Your ref
LU/214/19/PL

Our ref
PLAN-028990

Proposal: Erection of 2no. outbuildings to the rear of 18-22 East Street to provide communal/multi-functional space & therapy rooms ancillary to the lawful use of the site as a Private Detox & Rehabilitation Clinic (C2 Residential Institutions).

Site: LU/214/19/PL: - 18-22 East Street, Littlehampton, BN17 6AW.

Southern Water MapGuide Browser

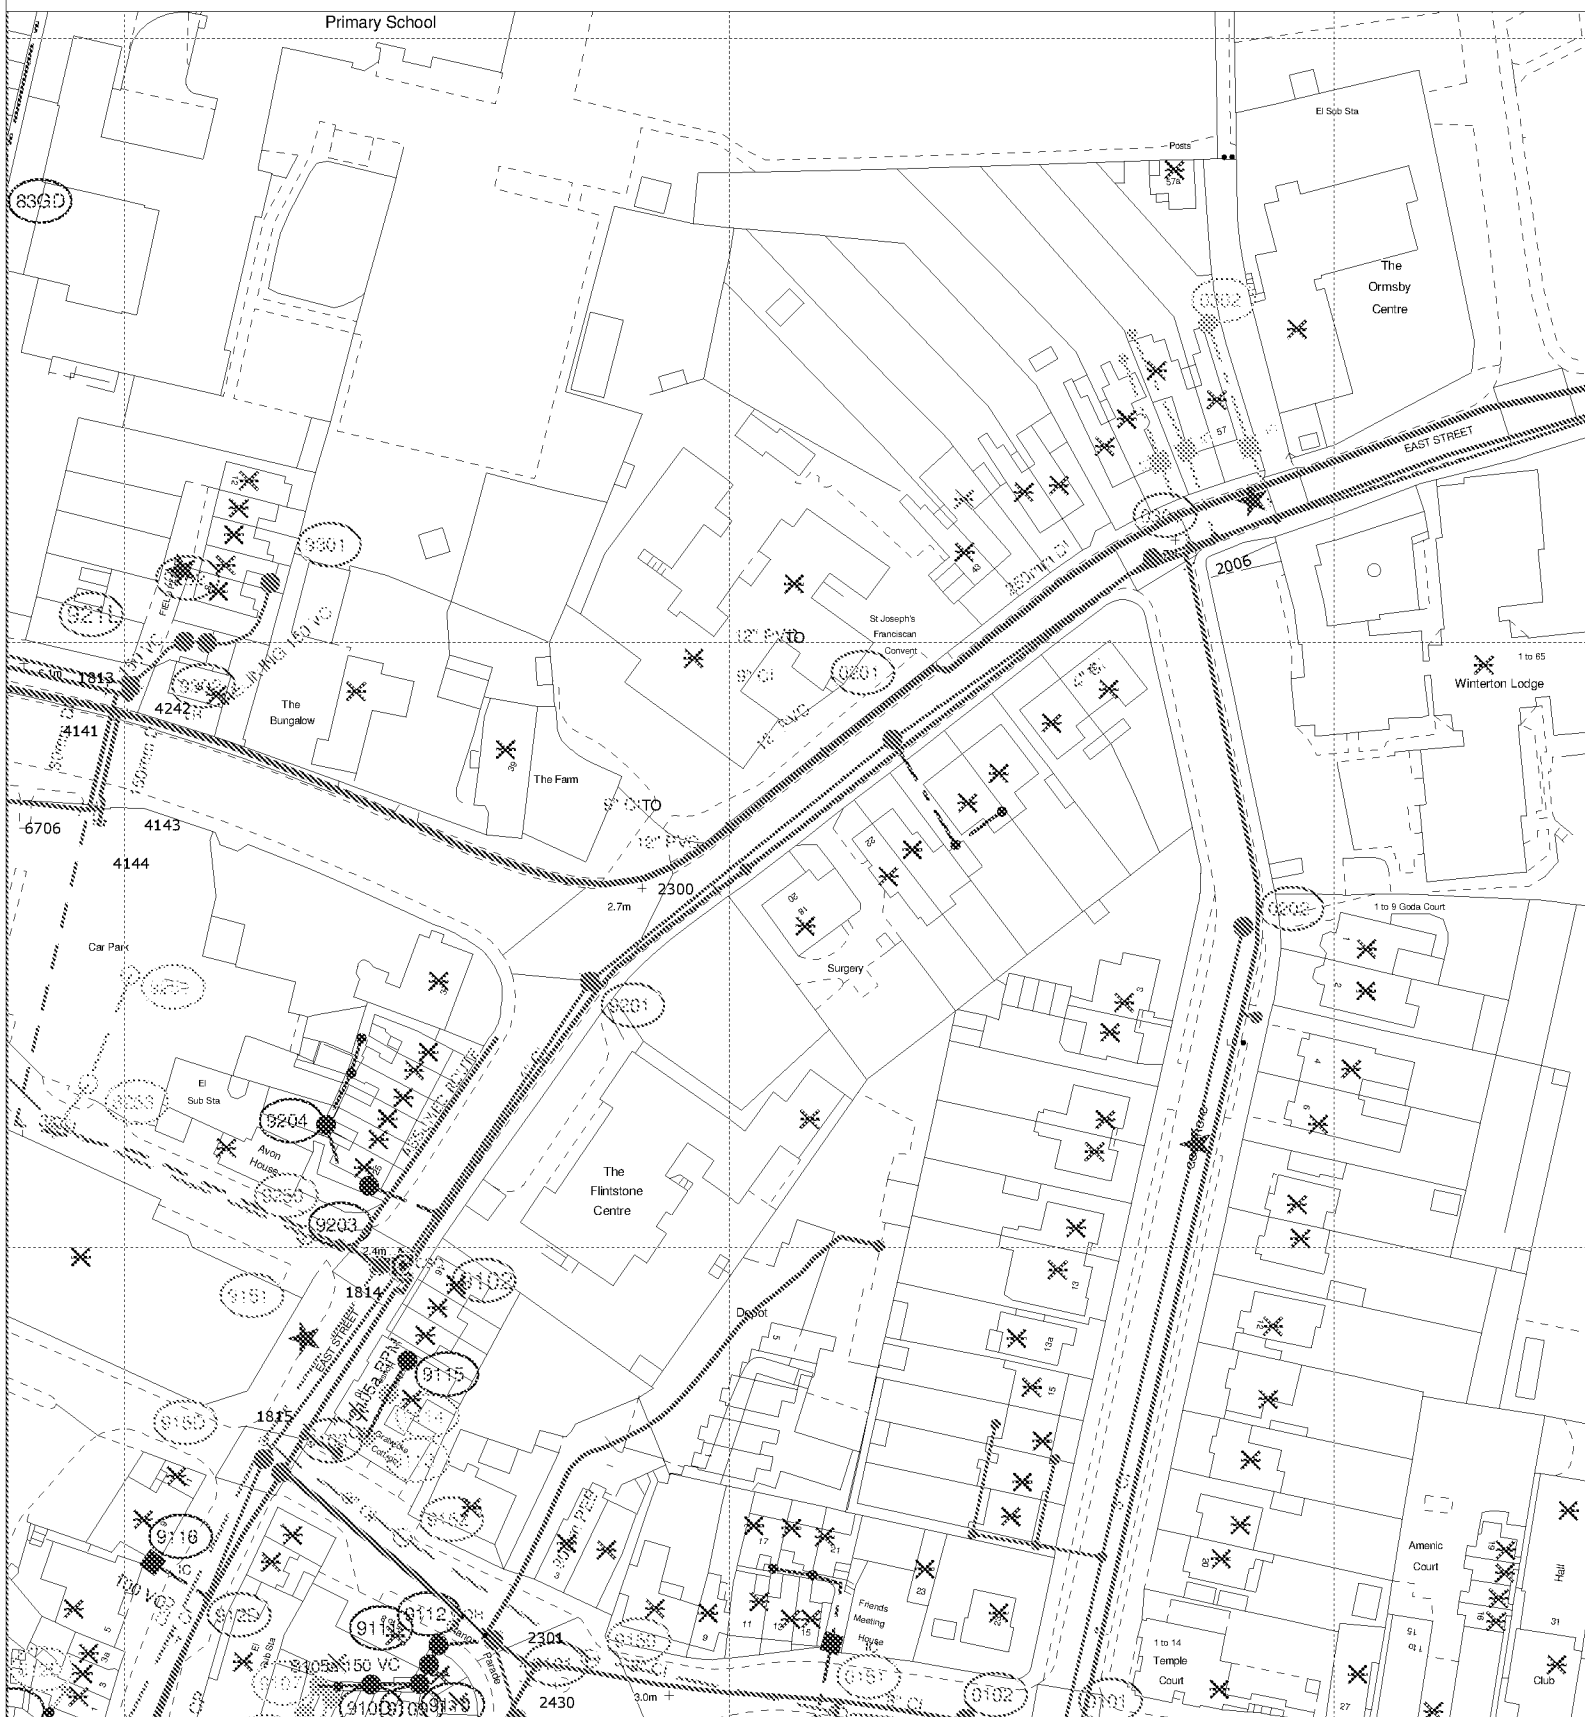
It is possible that a sewer now deemed to be public could be crossing the development site. Therefore, should any sewer be found during construction works, an investigation of the sewer will be required to ascertain its ownership before any further works commence on site.
